VIRGINIA ELECTRIC AND POWER COMPANY
RICHMOND, VIRGINIA 23261

NORTH ANNA POWER STATION UNIT NO. 1
ADDITIONAL INFORMATION REGARDING STEAM
GENERATOR CHEMISTRY AND CORROSION

REQUEST FOR ADDITIONAL INFORMATION REGARDING
STEAM GENERATOR CHEMISTRY AND CORROSION
NORTH ANNA POWER STATION
UNIT NO. 1

FIGURE 2.1 TYPICAL EFFECT OF BORIC ACID ON ALKALINITY AT FEEDTRAIN TEMPERATURES IN NORTH ANNA I

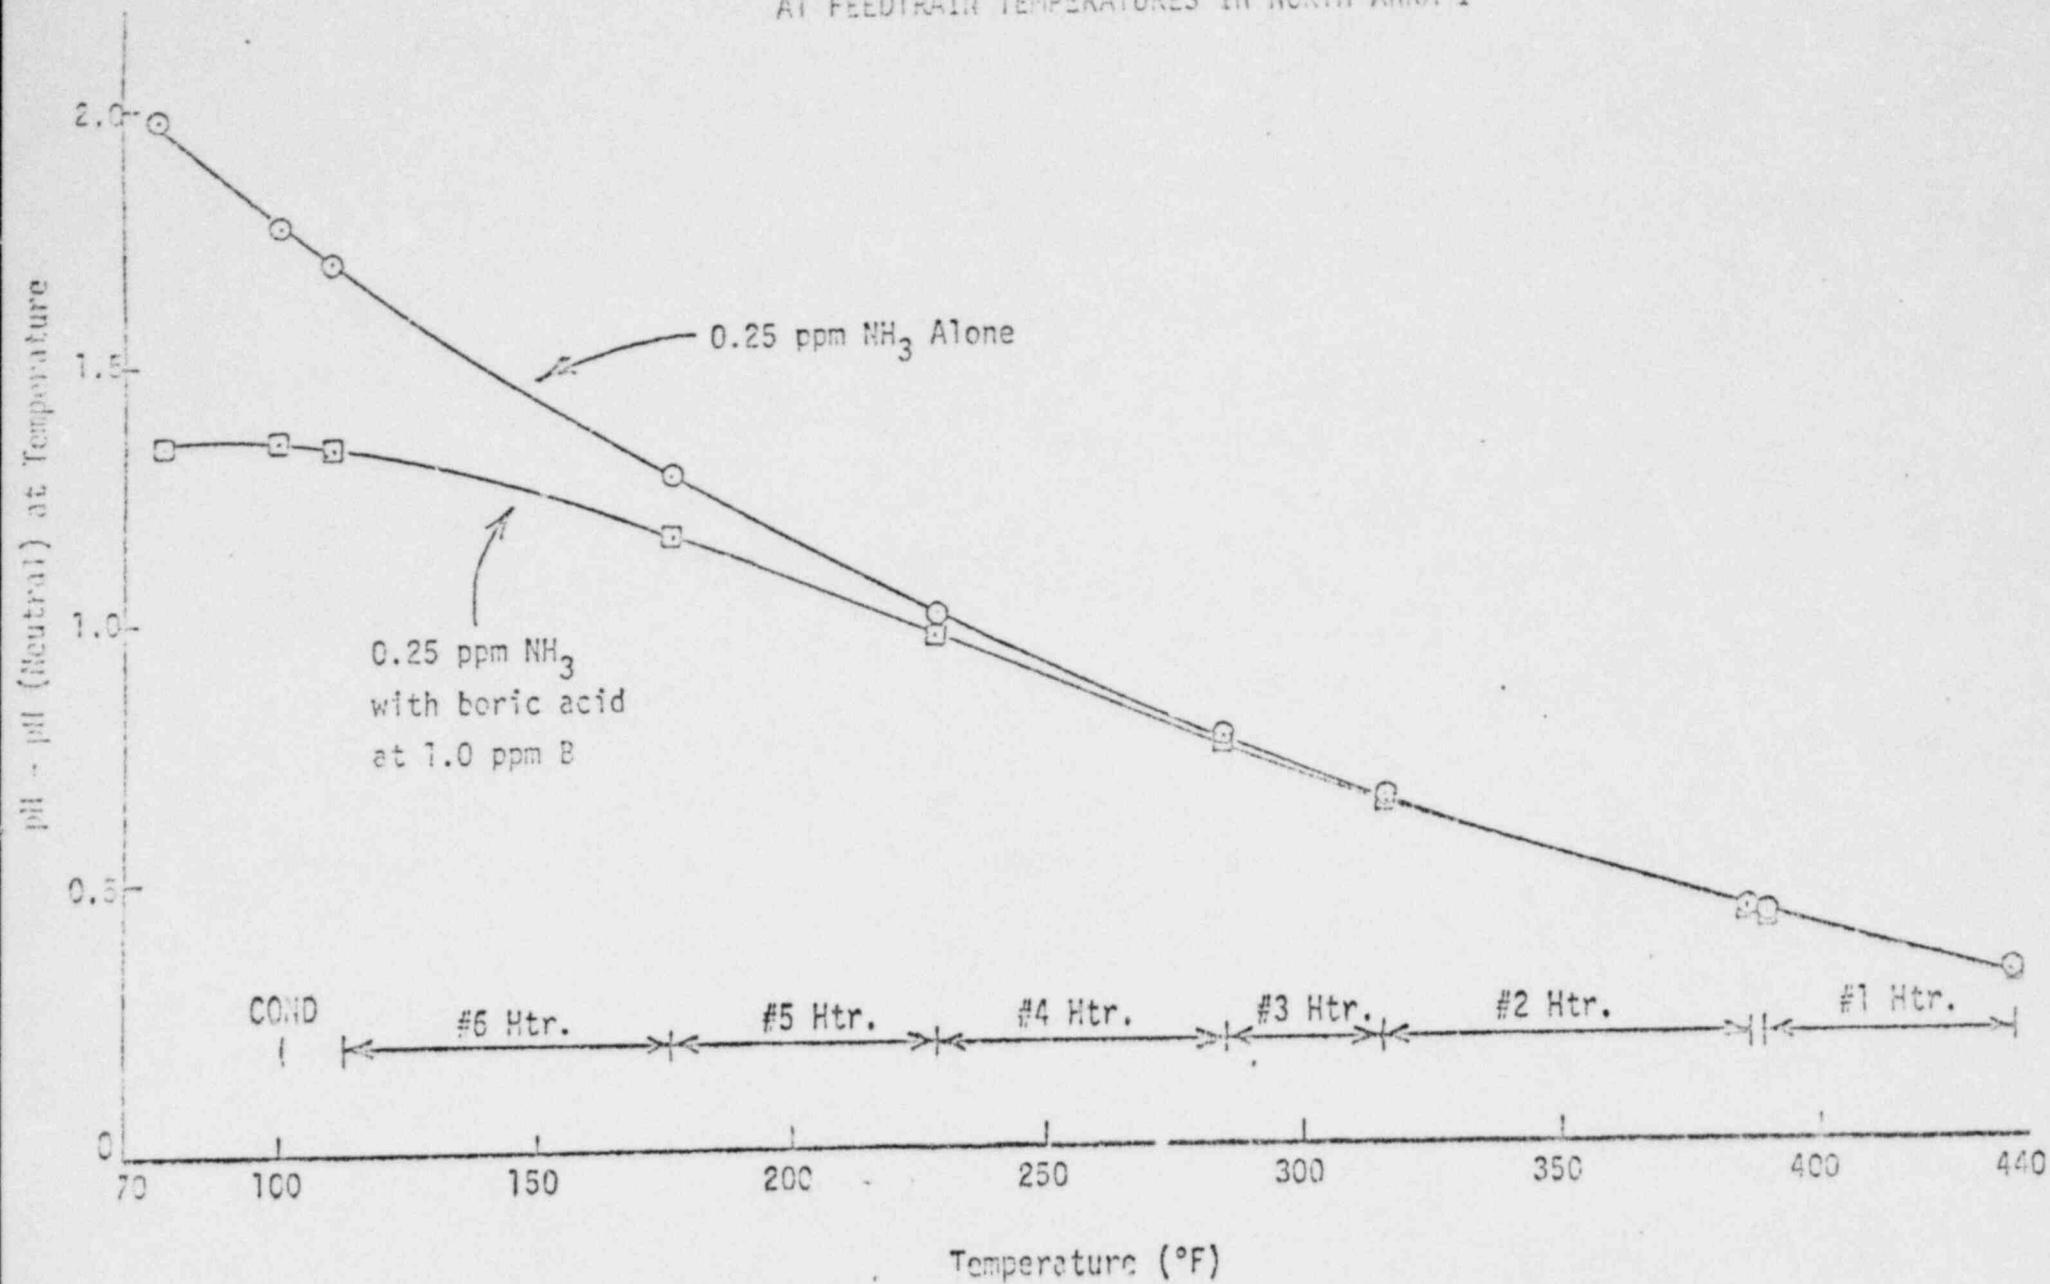
2. The effects of boric acid treatment on the non-stainless steel ferrous components in the feedwater train of the secondary system.

Figure 2.1 shows the typical effect of boric acid on alkalinity at feed-train temperatures in North Anna Unit No. 1, for 0.25 ppm NH₃ with and without 1.0 ppm B. The pH depression effect of boric acid is significant only in the No. 6 heater (110° - 176°F). This is the lowest temperature heater. The solutions are still above neutral, therefore, significant corrosion due to the presence of boric acid is not expected. At the higher temperatures the boric acid depression is negligible, the added ammonia being the chemically dominate species, thereby providing the desired alkalinity.

FIGURE 3.2 LOW POWER SOAK

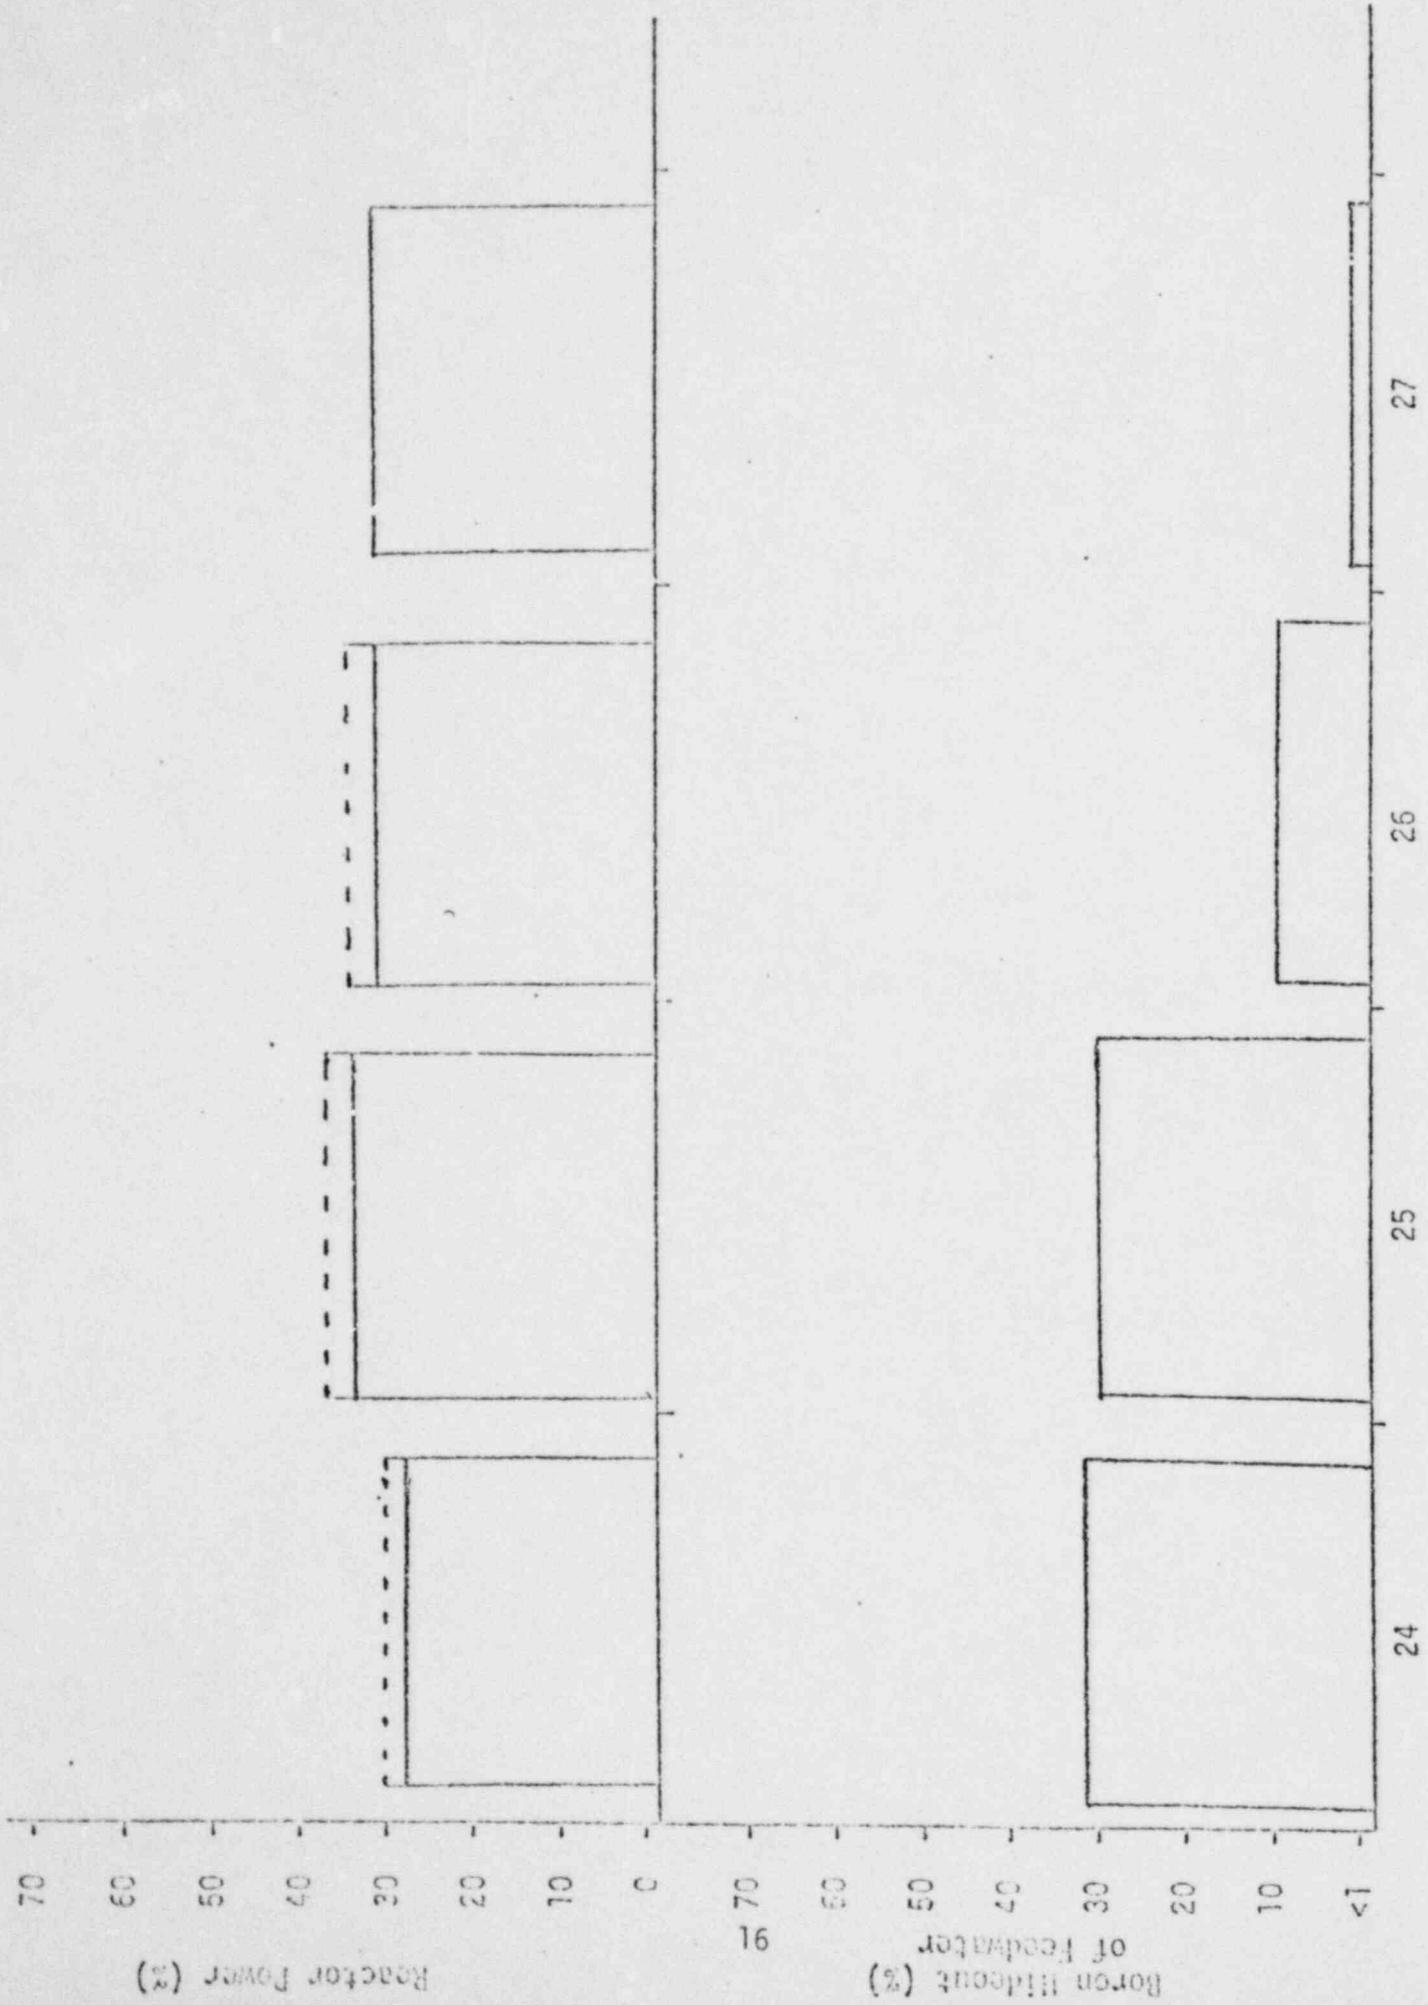
3. Preliminary data on the effectiveness of the boric acid treatment to stop tube support plate corrosion; i.e., (a) results of the low power soak treatment, (b) boron analysis on condensate, feedwater, blowdown, main steam and heater drains, and (c) hydrogen, oxygen, ammonia, pH, and cation conductivity analysis.

The boric acid soak commenced on January 23 at 2400 hours and was completed on January 27 at 2400 hours. The range of reactor power, during the 96 hour soak, was between 27% and 35% as shown in Figure 3.2.
